HISTORIC AND DESIGN REVIEW COMMISSION

HDRC CASE NO: 2020-243
ADDRESS: 245 LOVERA BLVD
LEGAL DESCRIPTION: NCB 9004 BLK 2 LOT 77 THRU 79
ZONING: R-4, H
CITY COUNCIL DIST.: 1
DISTRICT: Olmos Park Terrace Historic District
APPLICANT: Sergio Yutani/Space and Time Remodeling Inc.
OWNER: Thuc Tran
TYPE OF WORK: New construction of a rear accessory structure
APPLICATION RECEIVED: May 04, 2020
60-DAY REVIEW: Not applicable due to City Council Emergency Orders
CASE MANAGER: Huy Pham

The applicant is requesting a Certificate of Appropriateness for approval to construct a rear accessory structure.

ELEVATIONS
WINDOWS & DOORS
SCHEDULES.

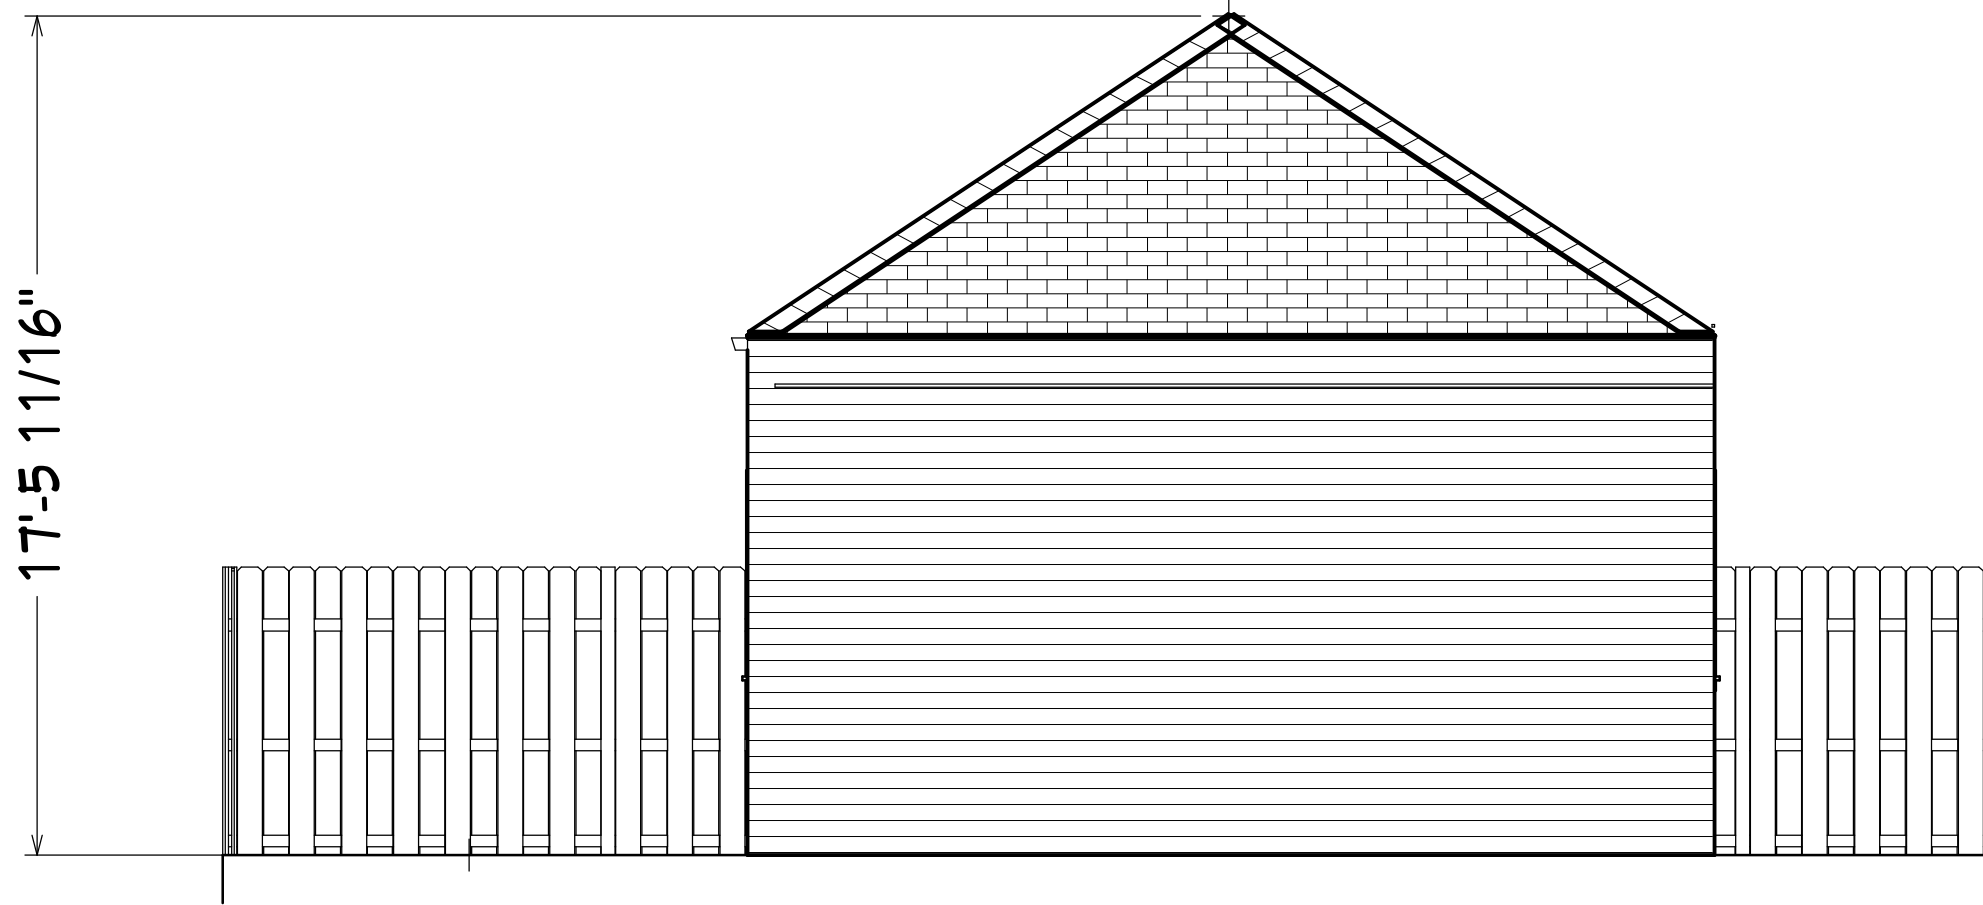
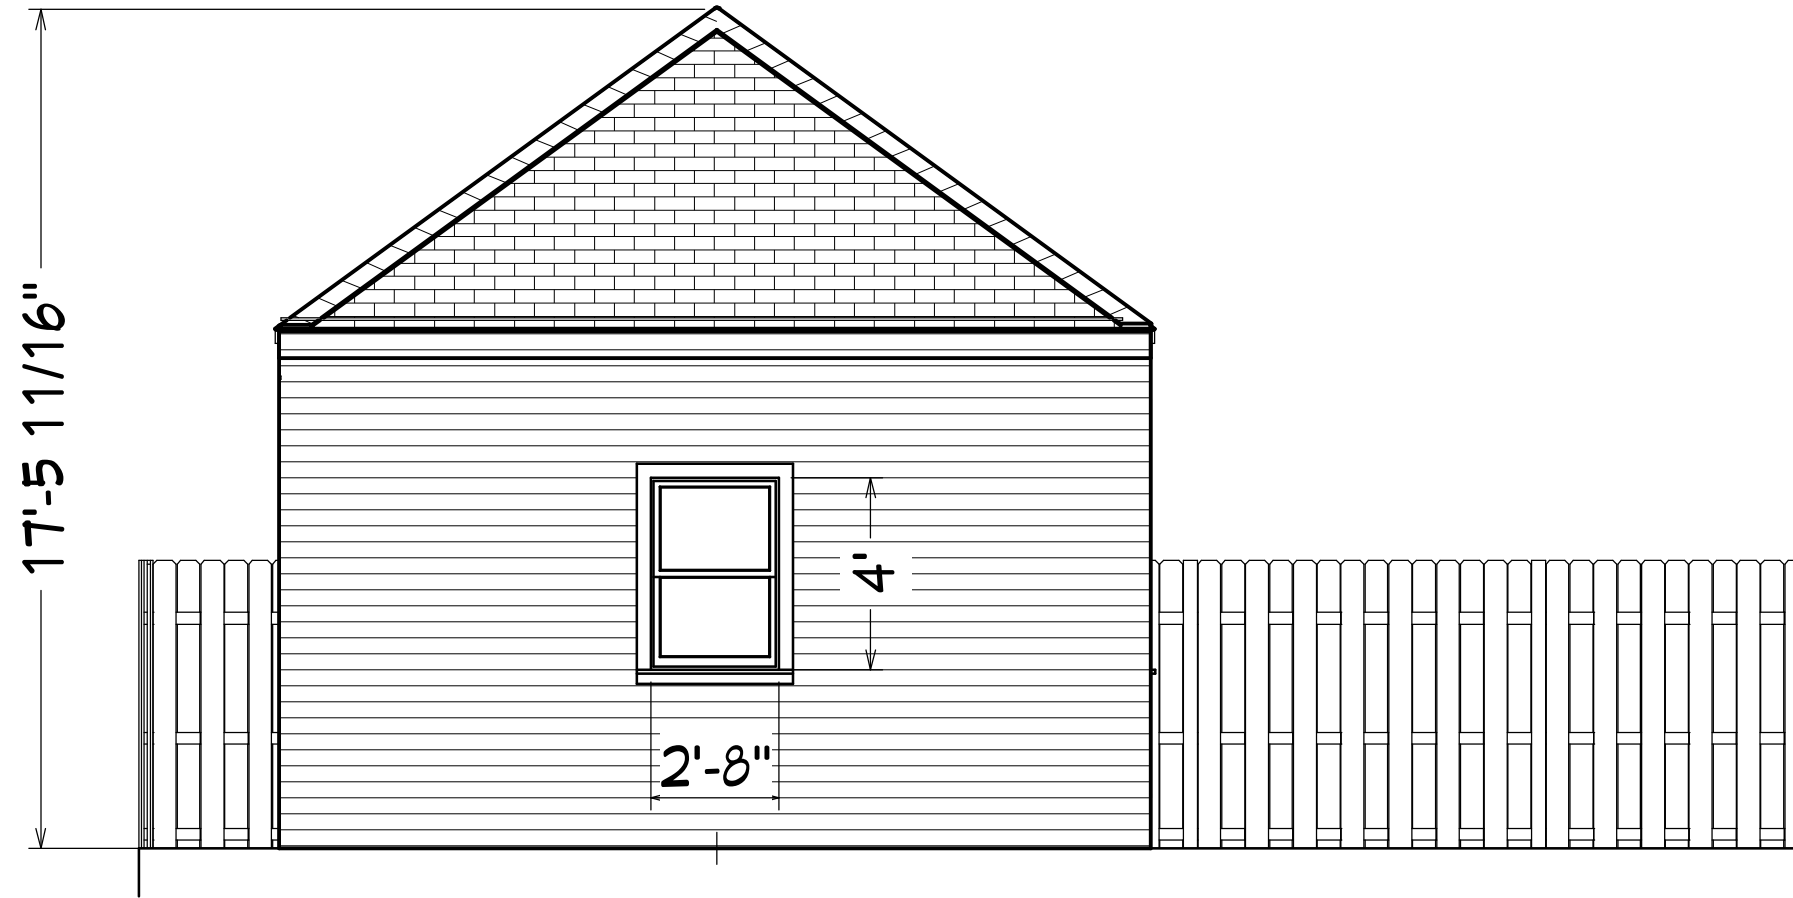
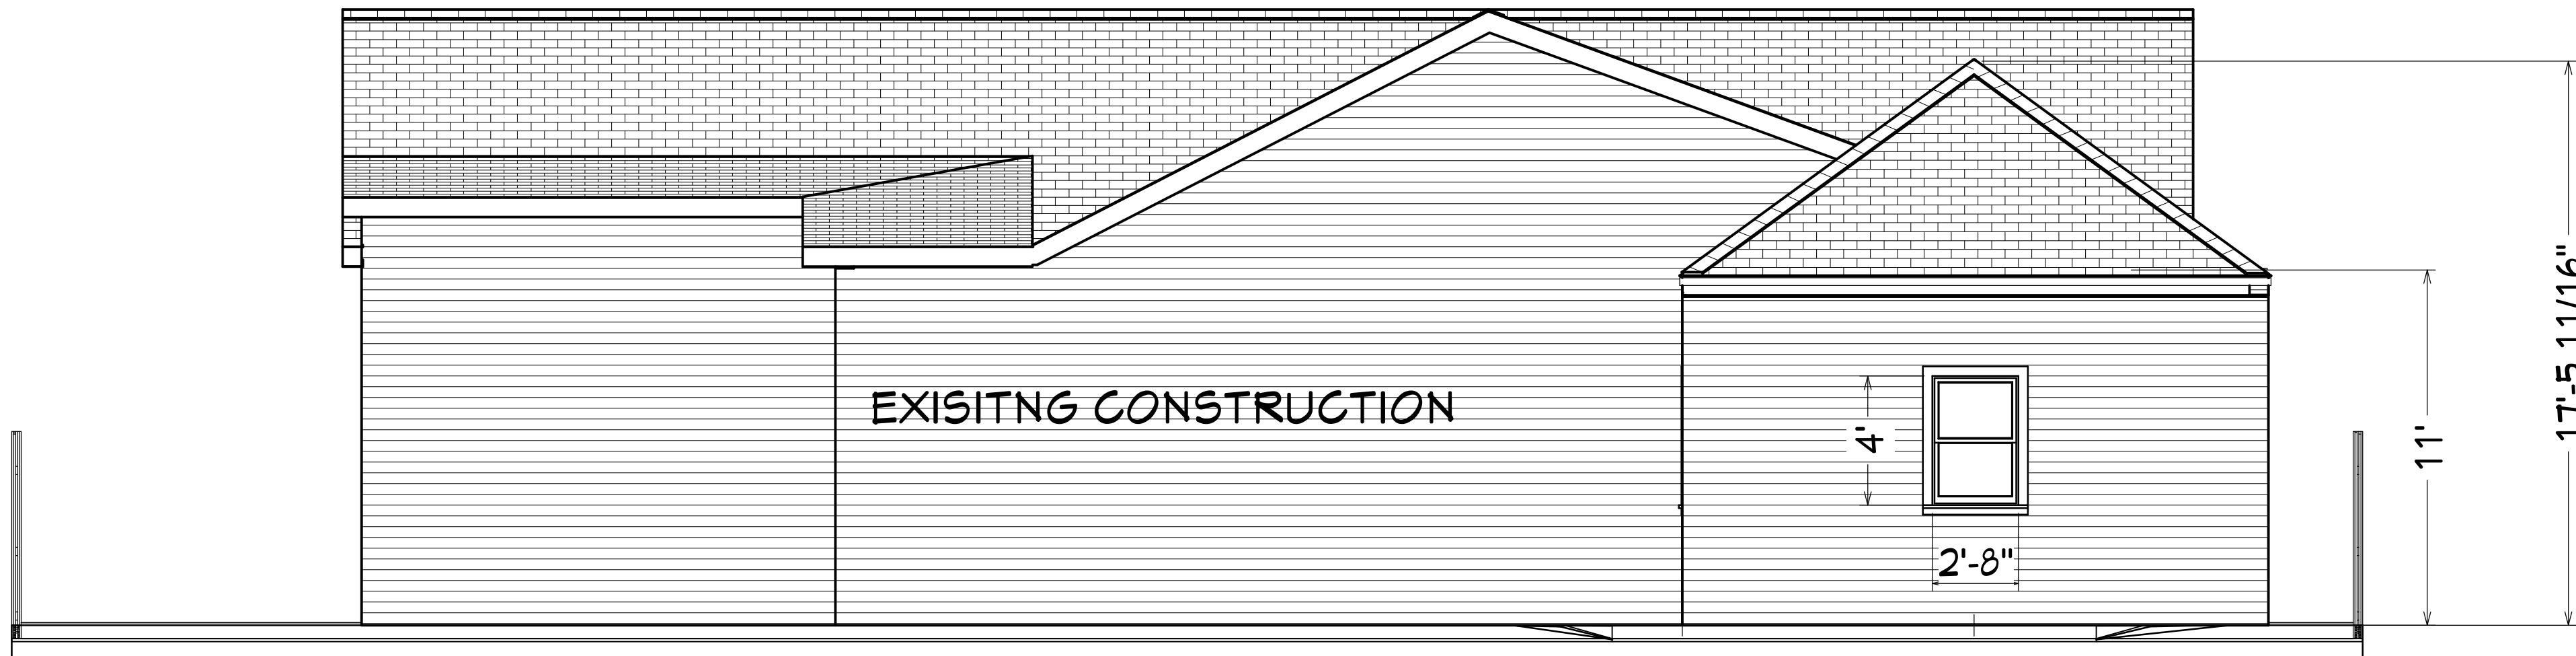
- iii. ACCESSORY STRUCTURE – The applicant has proposed to construct a 360 square-foot, 1-story rear accessory structure featuring HardiePlank lap siding, vinyl windows (JELD-WEN V-4500), a composite MDF door, and a hipped composition shingle roof.

- vi. CHARACTER – Per the Guidelines for New Construction 5.A.iii., applicants should relate new garages and outbuildings to the period of construction of the principal building on the lot through the use of complementary materials and simplified architectural details. Staff finds that the HardiePlank siding is appropriate if it features a smooth finish with no faux wood grain texture and feature a 4-inch exposure.

- vii. WINDOWS AND DOORS – Per the Guidelines for New Construction 5.A.iii., applicants should design window and door openings to be similar to those found on historic garages or outbuildings in the district or on the principle historic structure in terms of their spacing and proportions. Staff finds that proposed fenestration pattern generally relates to the historic structure. However, staff finds that proposed windows (JELD-WEN V-4500) do not adhere to the Standard Stipulations for Windows in New Construction regarding the sash size, the depth profile, and the manufactured color; an appropriateness window product should be submitted to staff.

- i. That the HardiePlank siding feature a smooth finish without faux wood grain texture and feature a 4-inch exposure.
- ii. That the structure features windows that adheres to the *Standard Specifications for Windows in New Construction* instead of the proposed JELD-WEN V-4500; an appropriate window must be submitted to staff.
- iii. That the applicant is responsible for complying with all setback requirements and obtain a variance if required for permitting.
